January 12, 2026
Subject: Merrill's Corner Bridge
Replacement
WIN: 027530.00
Location: **Brownfield**
Amendment No. 3

REMOVE Sheet Number 22 of 26, SUPERSTRUCTURE dated 12/3/2025 (1 page) and **REPLACE** with the attached Sheet Number 22 of 26, SUPERSTRUCTURE dated 1/9/2026 (1 page).

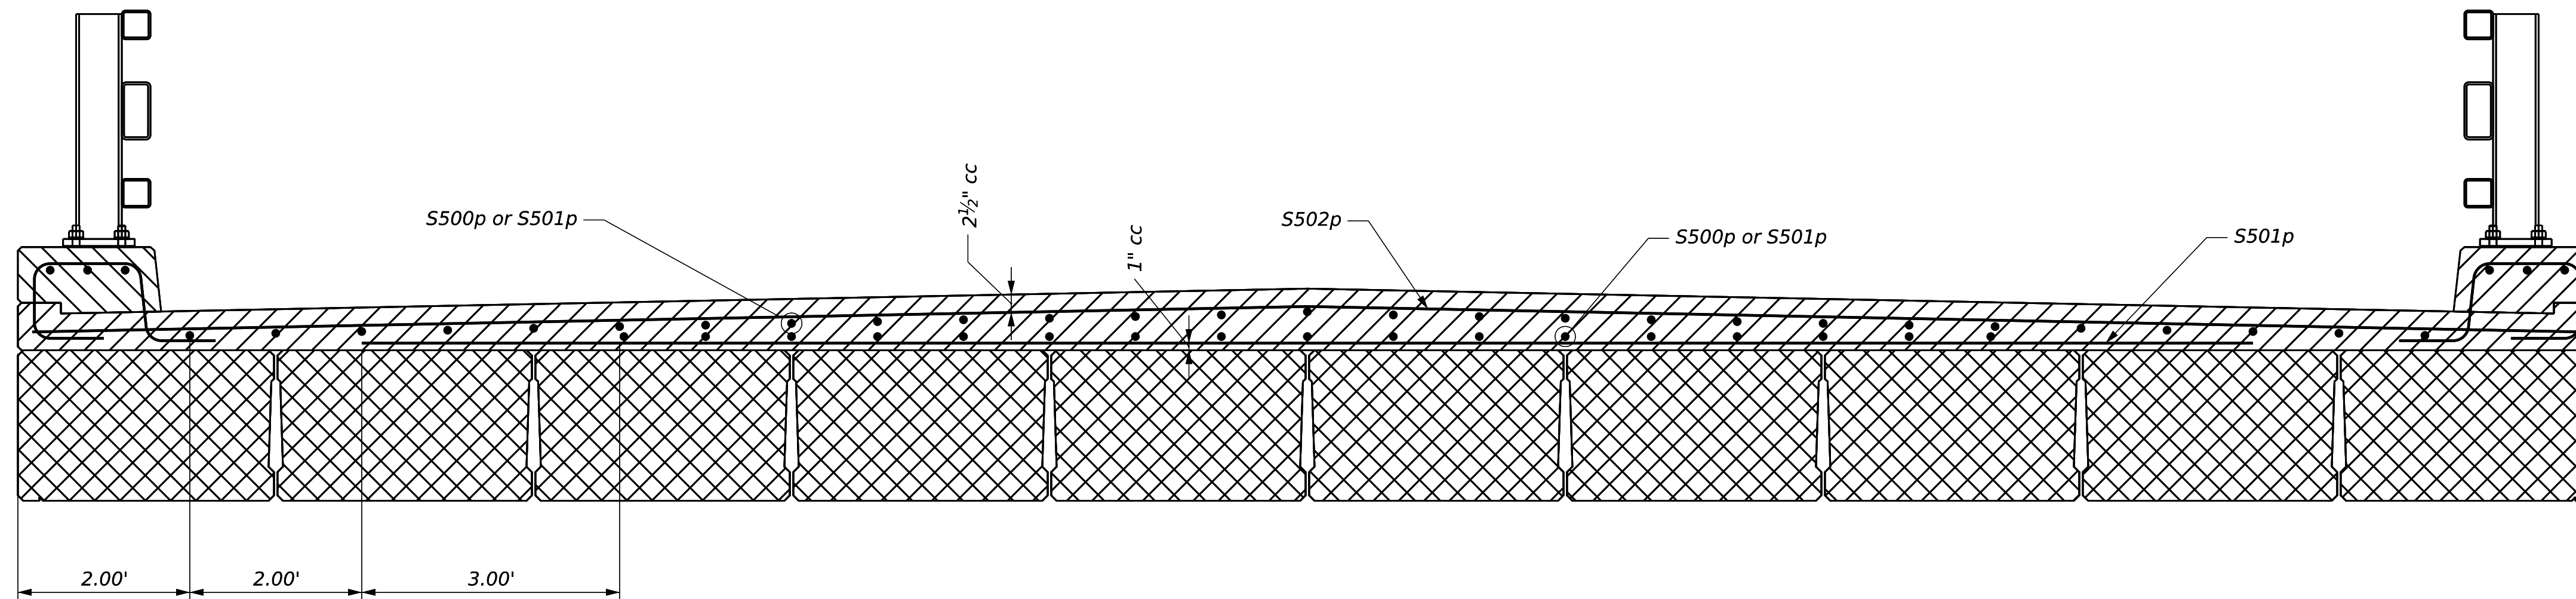
Question: In reference to Sheet 22, Note 6 is the reinforcing steel incidental or does pay in the unit price items?

Response: Payment for reinforcing steel fabricated, delivered, and placed in the cast-in-place portion of the structural concrete slab will be paid for by the related 503 and 530 Pay Items. See Sheet 24 of the Plans for the reinforcing steel schedule for the structural concrete slab.
